Access Compliance Report

Public Rights-of-Way

(Curb Ramps)

Intersection ID: 9783	Main Street: WARP_ST	Cross Street: DONATELLO_AV	Location: SW
ADA ID: CBC8CCC25726	Ramp Type: Perp	Initial Pass/Fail: Pass	Overall Compliance: No
		Severity Score: 0

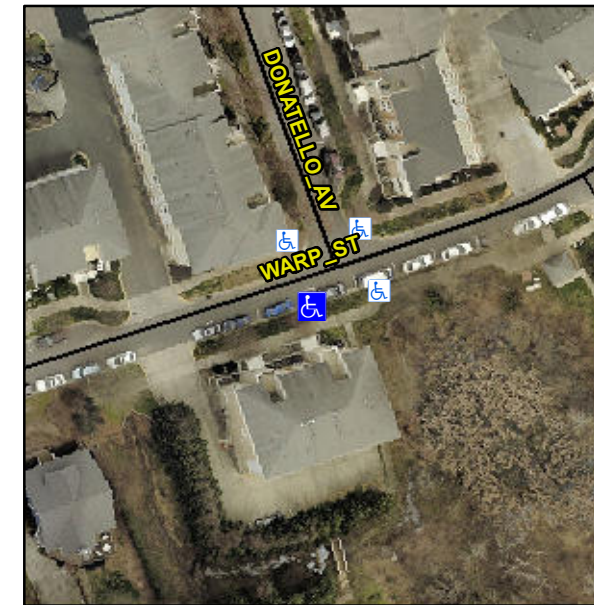
Possible Solutions:

Remove & Replace Detectable Warning System.
